Additional Information for XCN08014: Q&A

XTP036 (v1.0) October 20, 2008

Q1. Why is Xilinx standardizing to a 2-layer package substrate for Spartan-3A FT256 product?

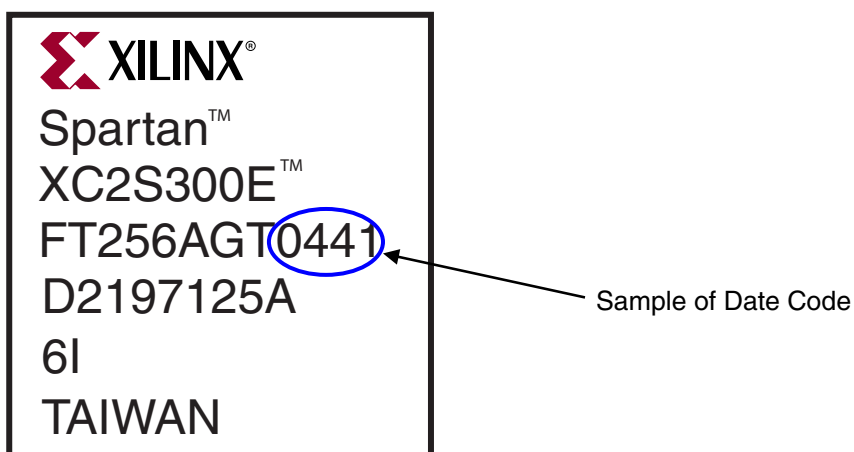
Q8. How do I know whether I have the 2-layer substrate after January 10, 2009?

A. Xilinx will update this document with the exact cutover date codes to 2-layer substrates. The Date Code can be found on the package top mark, as indicated below:
